TPB Ref.: A/NE-FTA/239

# Proposed Temporary Vehicle Repair Workshop for Private Car for a Period of 3 Years at Lot 143 (Part) in D.D. 52 & Adjoining Government Land, Sheung Shui, New Territories

Appendix Ib of RNTPC Paper No. A/NE-FTA/239B

## Response to DSD's comments (Application No. A/NE-FTA/239)

Drawing Title 順目:
Details of Proposed Surface U-channel

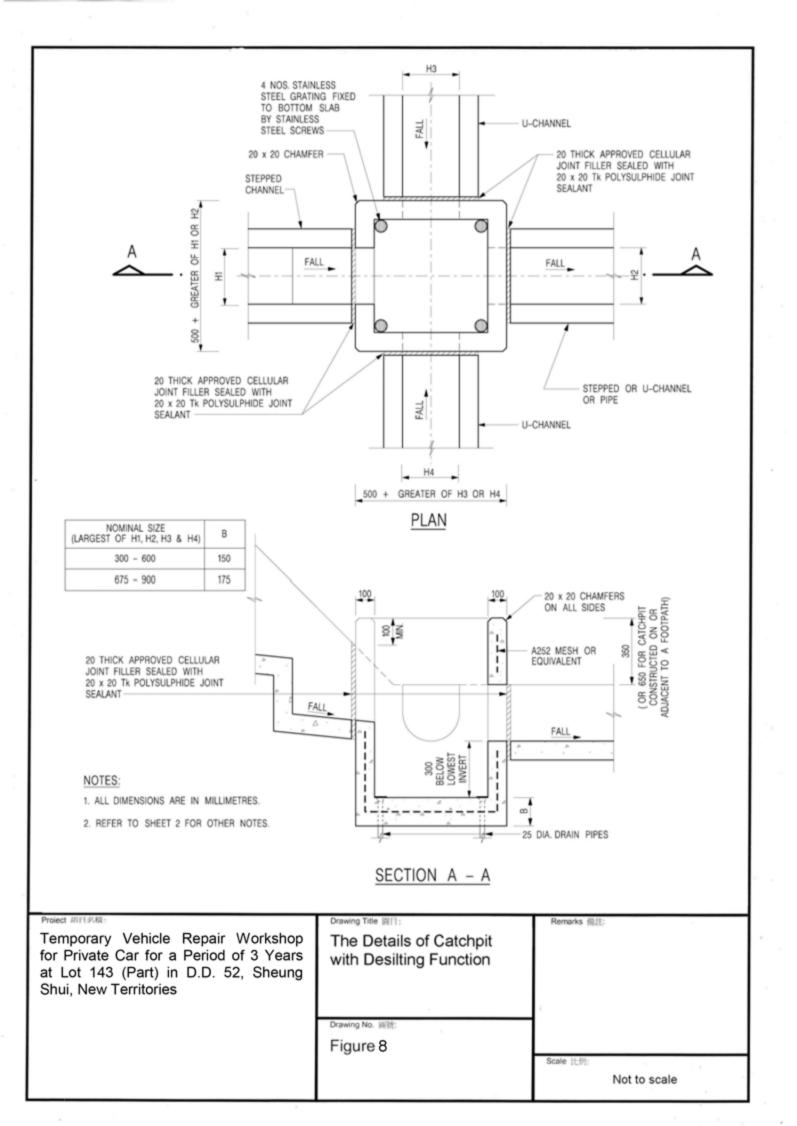
3. Please validate if 1:22 gradient U-channel can be practically implemented on site. Please advise the utilization of the proposed 300mm U-channel.	Refer to the drainage design submitted before, the surface is 10,962 l/min. In accordance with the Chart or the Rapid Design of Channels in "Geotechnical Manual for Slopes", 375mm surface U-channel in 1:100 gradient will be adpoted to replace 300mm U-channel in 1:22 gradient, please see the enclosed Figure B and revised Figure A

- (a) The utilization of the proposed 300mm U-channel is about 50% at the proposed gradient 1:22 so that it is found adequate for the proposed development.

Photo View - P1

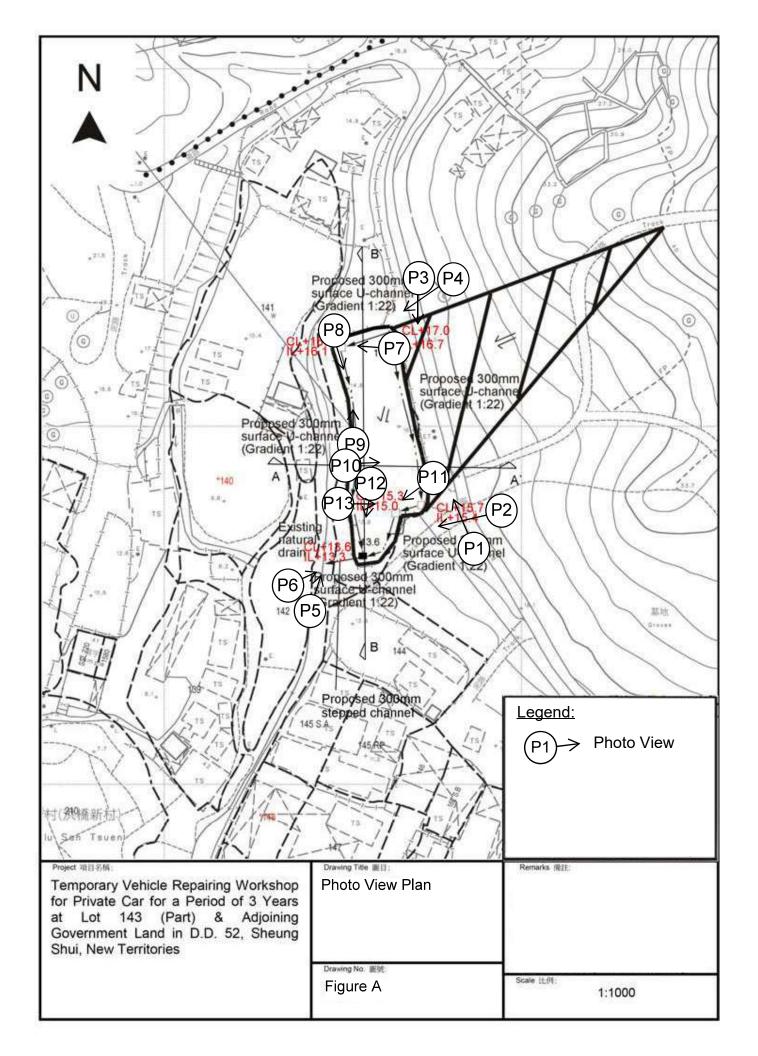
1. Please advise the clearance between the proposed site	Distance between the proposed site hoarding and the
hoarding and the existing streamcourse to the west of the	existing streamcourse is around 200mm (see Plate P6)
applicant site	
2. Our previous comment under Para 3 (h) in the memo ref.	Please see the enclosed photo view report.
(013HMX) in MN 10/N/DD52/143 remain valid. Site photos within	
and around the site including the condition of existing	
streamcourse should be provided.

2. My previous comment regarding the clearance between the proposed site hoarding and the existing streamcourse was NOT responded, please clarify.	Please see the enclosed photo Plate A1 shown the distance between the proposed site hoarding and the existing streamcourse is around 200mm.

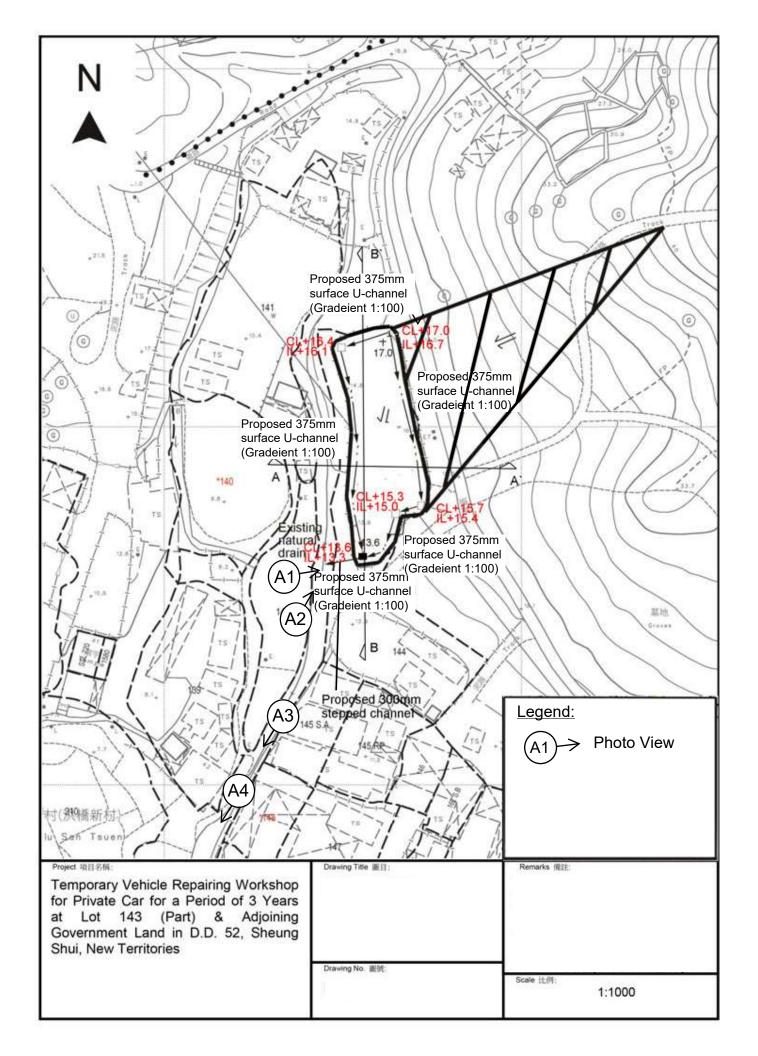
1. Please provide photos for the proposed drainage discharge point, i.e. the natural streamcourse to the west of the application site. The applicant should check and ensure that the existing	Please see the enclosed photos Plate A1 to A4 and photo view report for your easy reference.
streamcourse to which the proposed connection will be made have adequate capacity and satisfactory condition to cater for the additional discharge from the application site.	As no site formation works has been carried out on the propsoed site and the catchment area hasn't been changed, it is therefore, no additional discharge will be discharged to the existing streamcourse.
